SEWAGE DISPOSAL SYSTEM

MARYLAND STATE DEPARTMENT OF HEALTH

SUBDIVISION Lower Trail ROAD 16488 Route 144 LOT 1

PROPERTY OWNER Roger W. Haynes

PERMIT CARD

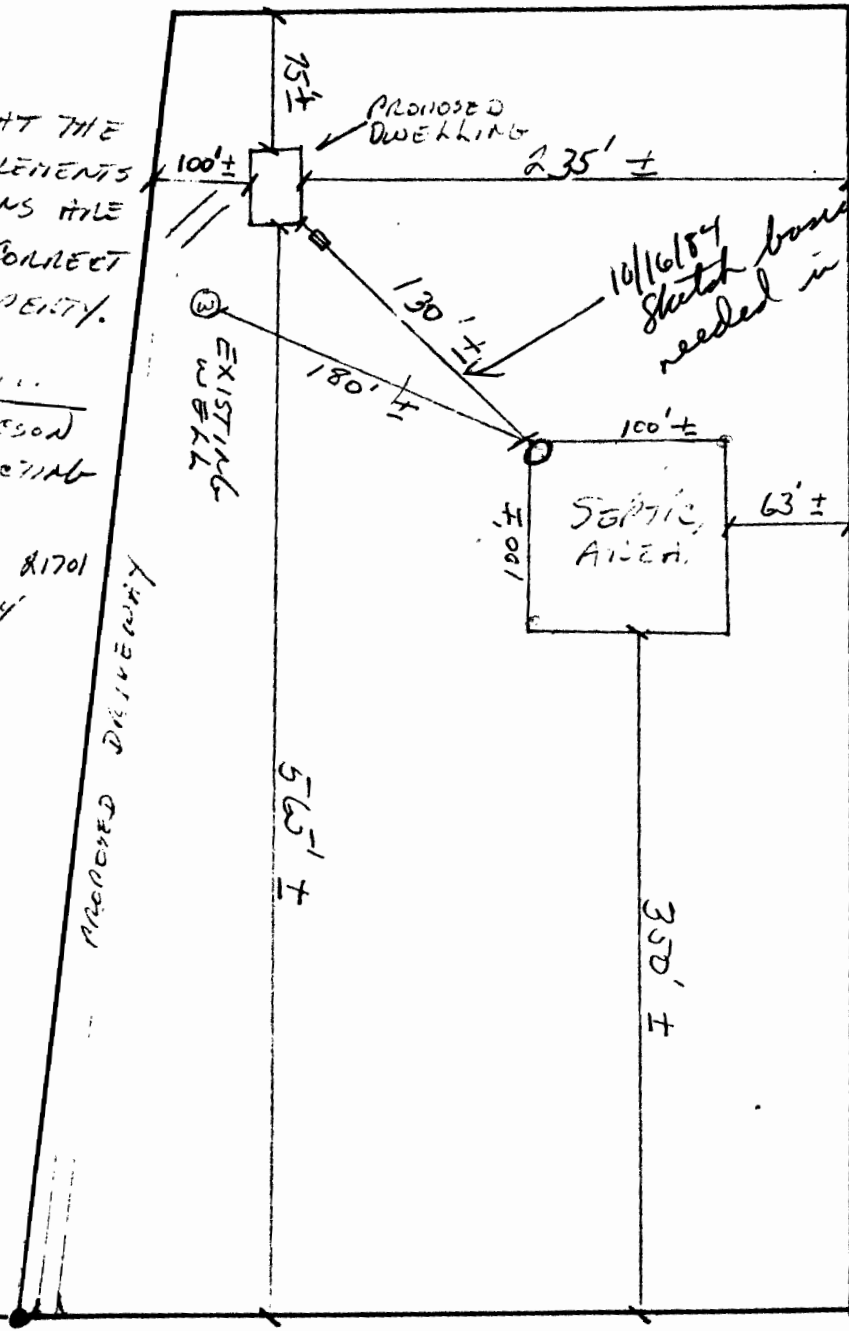
REMARKS 11-12-85 OK TO ADD STONE TO TRENCH; NEED C/O ON ST AND ALL PIPE WORK SET
11-25-85 NEED C/O OR COVER PORT ON ST; OK TO COVER PIPE WORK + TRENCH. STAGED
11-25-85 C/O installed. SA.

ROBERT W. HAYNES
 LOT 1
 LOWER TRAIL

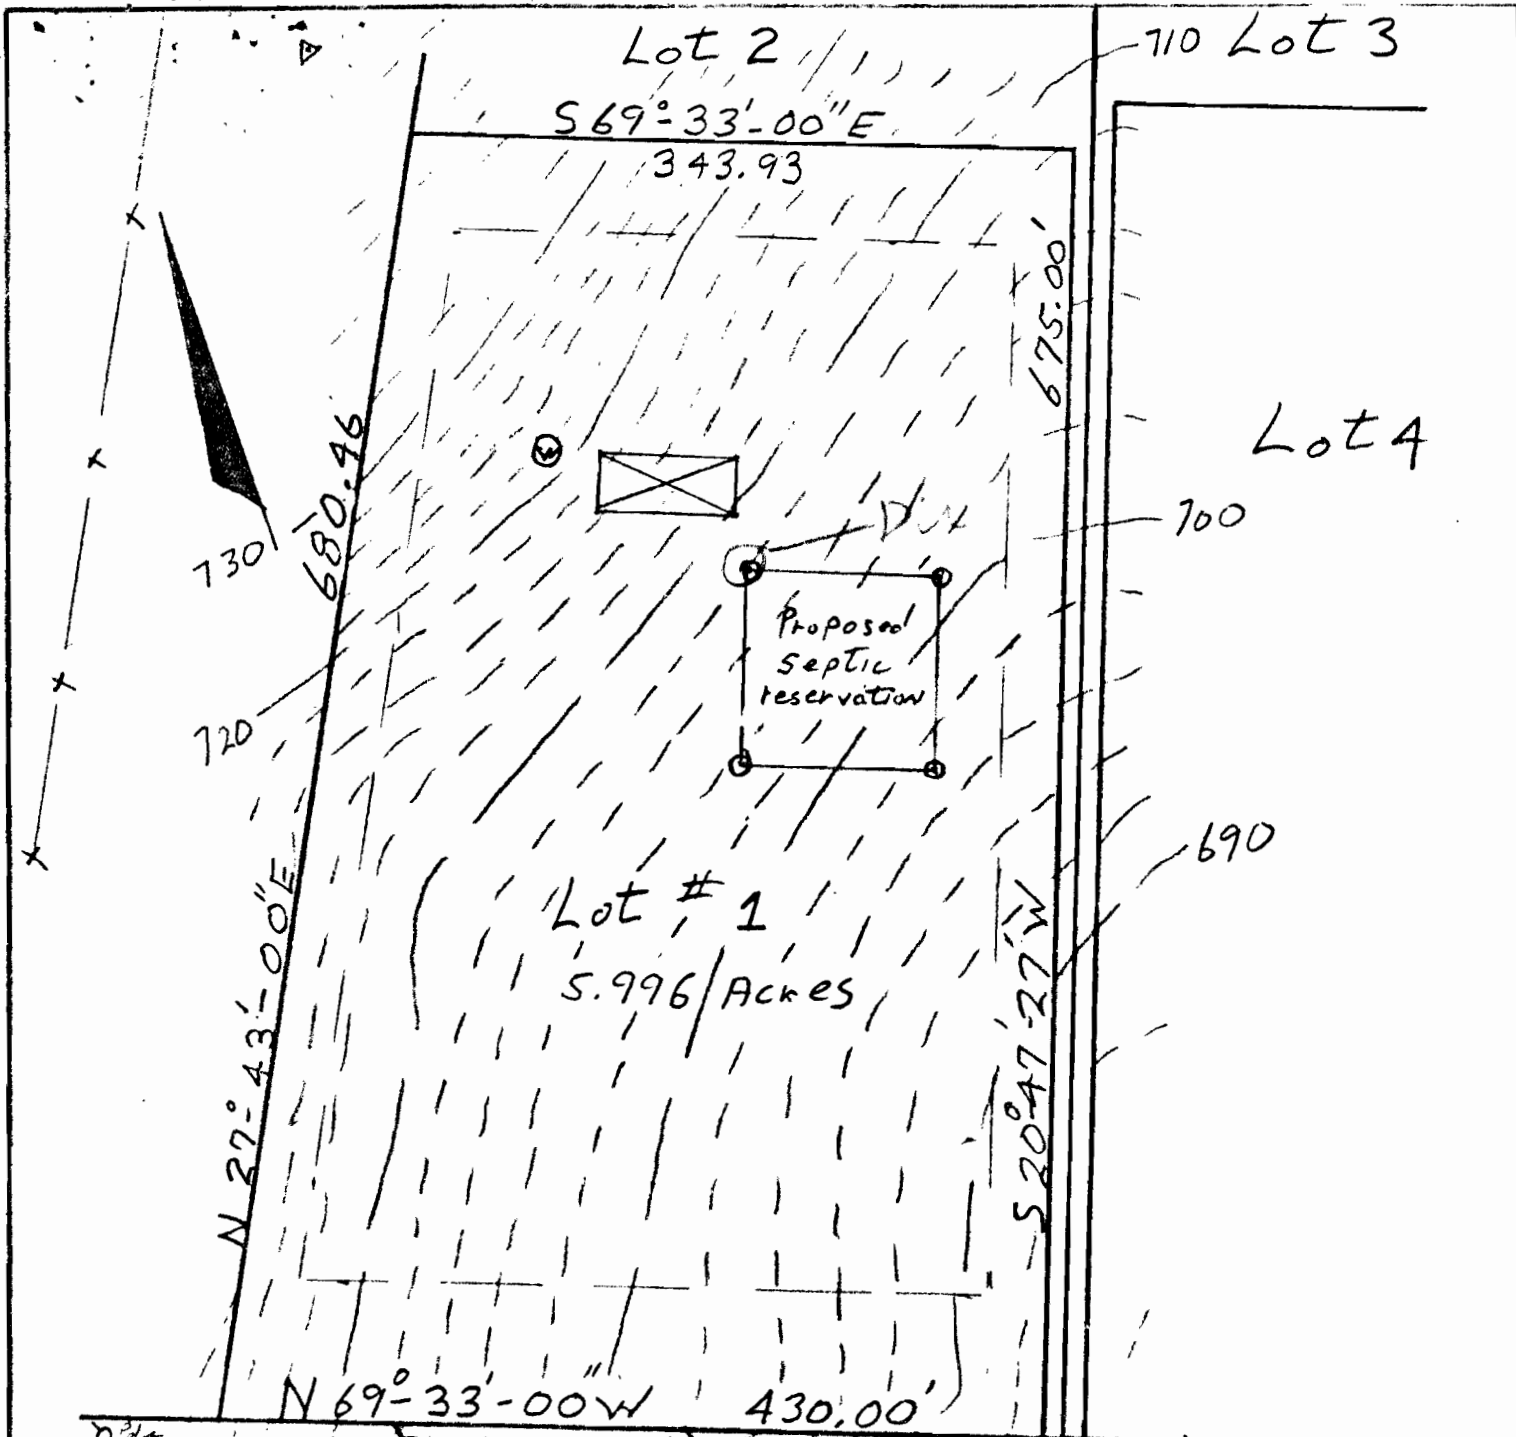
OK but CLEANOUT
 75 ft
 J. Shu
